BRUNSWICK STEAM ELECTRIC PLANT, UNIT NOS. 1 AND 2
DOCKET NOS. 50-325 AND 50-324/LICENSE NOS. DPR-71 AND DPR-62
RESPONSE TO REQUEST FOR ADDITIONAL INFORMATION REGARDING
REQUEST FOR LICENSE AMENDMENTS - EXTENDED POWER UPRATE
(NRC TAC NOS. MB2700 AND MB2701)

Response to Request for Additional Information (RAI) 20

Response to Request for Additional Information (RAI) 20

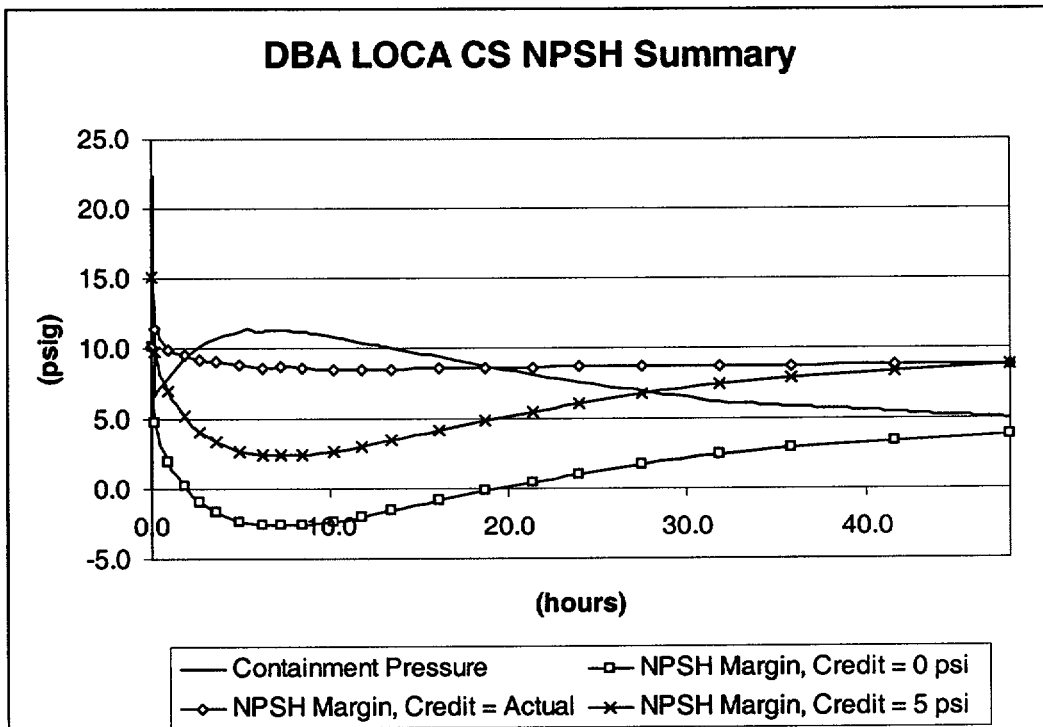
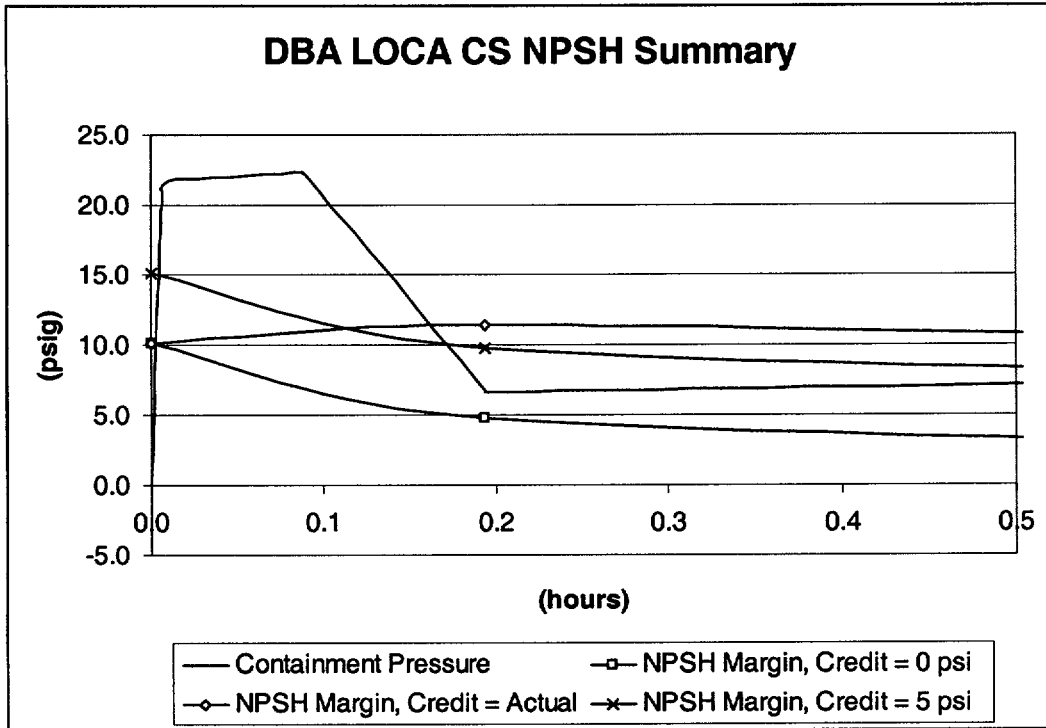
NRC Question 20-1

Please provide (1) a plot of long term RHR NPSH requirements based on Table 7-1 of CP&L's EPU amendment request dated August 9, 2001, and (2) a plot of long term CS NPSH requirements based on Table 7-2 of CP&L's EPU amendment request dated August 9, 2001.

Response to Question 20-1

The following graphs provide the requested information.

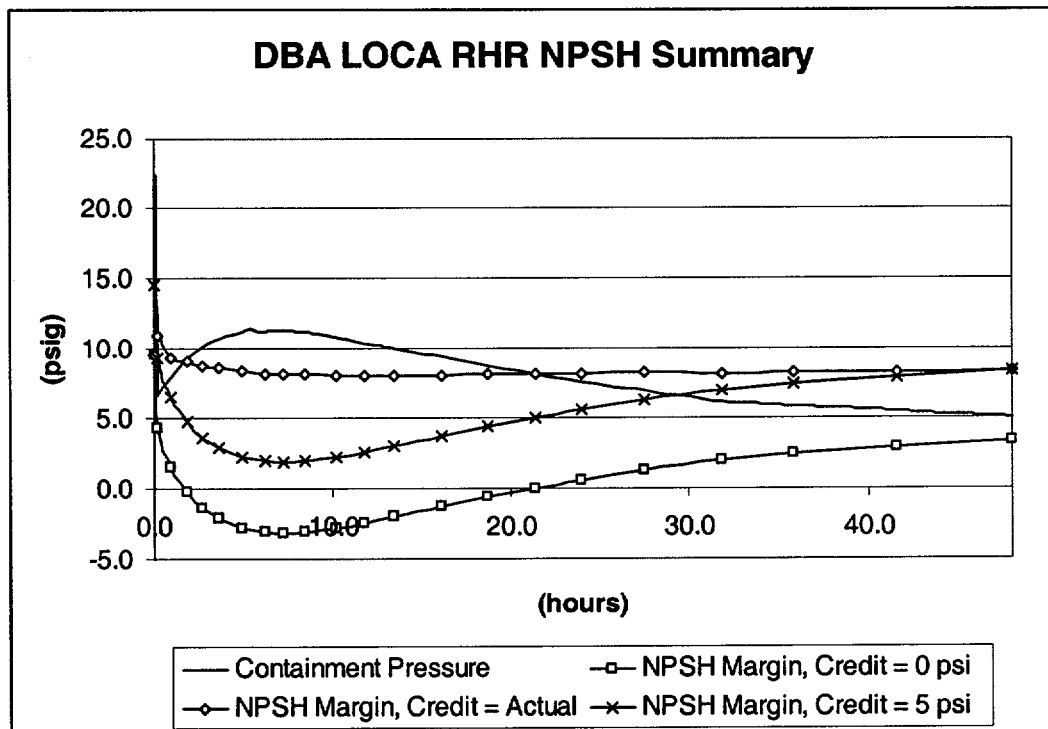
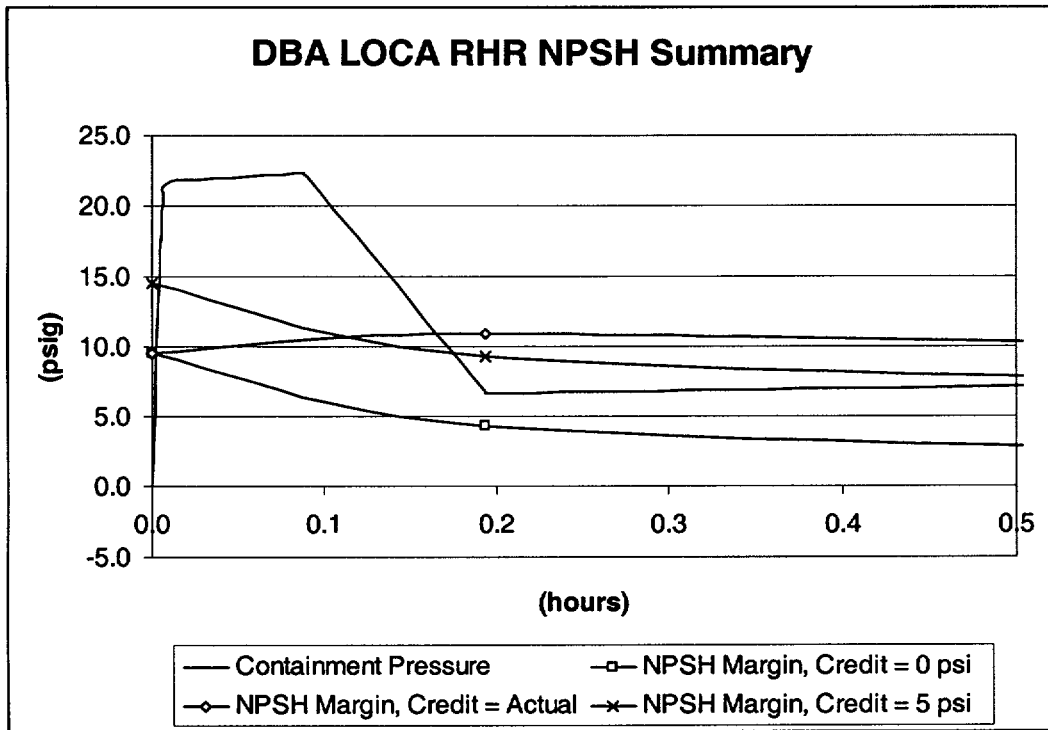
NRC Question 20-2

Please provide (1) a plot similar to "Figure 7 - Uncontrolled Drywell Hydrogen and Oxygen Concentrations for EPU," of the RAI 14 response, showing Controlled Drywell Hydrogen and Oxygen Concentrations for EPU and (2) a plot similar to "Figure 8 - Uncontrolled Wetwell Hydrogen and Oxygen Concentrations for EPU," of the RAI 14 response, showing Controlled Wetwell Hydrogen and Oxygen Concentrations for EPU.

Response to Question 20-2

The following figure provides the controlled and uncontrolled concentrations of hydrogen and oxygen for the containment drywell and wetwell mixed volume.
